RE: COMMENTS ON THE DRAFT EIR FOR THE PROPOSED  
PALISADES LANDMARK CONDOMINIUM PROJECT  
EAF NO.: ENV-200-2696-EIR  
SCH NO.: 2002051086

RE: Project ENV-2000-2696-EIR  
Palisades Landmark Condominium Project  
Reference Nos SCH# 2002051086  
17331-17333 Tramonto Drive

Re: EIR Case No.; ENV-2000-2696-EIR, Ref. No. SCH # 2002051086  
17331-17333 Tramonto Drive, 82 unit condominium

**1740 Revello Drive, Pacific Palisades: Base View Station 1**

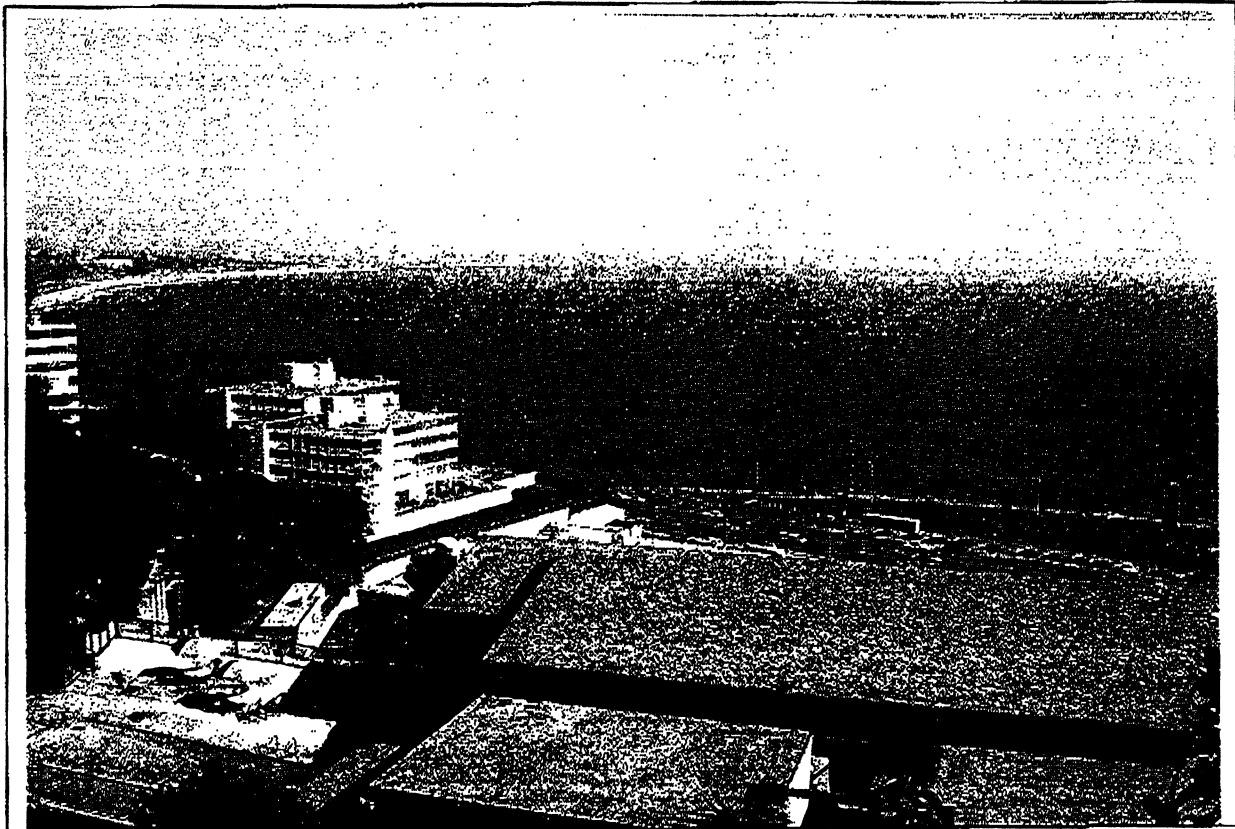
With the sparse data provided for the project, we have painstakingly attempted to undertake a viewshed analysis from our property and have come to the conclusion that the project, as proposed, would greatly affect our viewshed, especially our shoreline views. If you have information to the contrary, or if the developers have undertaken changes to their plans that indicate that the proposed construction does not affect our viewshed, please provide us with the appropriate documents or information.

While the burden of proof that our viewshed is affected and that the project's viewshed design is flawed should not rest on us, the affected homeowners, we are willing to meet with representatives of the City and a surveyor for the developer at any time to further analyze the viewshed issue from base viewpoint stations on our property. The attached photographs were taken from such a base station (lower deck) whose viewshed would be greatly affected.

We also insist that the project ridgelines, inclusive of all projections above the roofs be flagged (and certified as to accuracy prior to further permit processing) to provide the community as well as affected neighbors with a better understanding of the project's impacts and potential view obstructions.
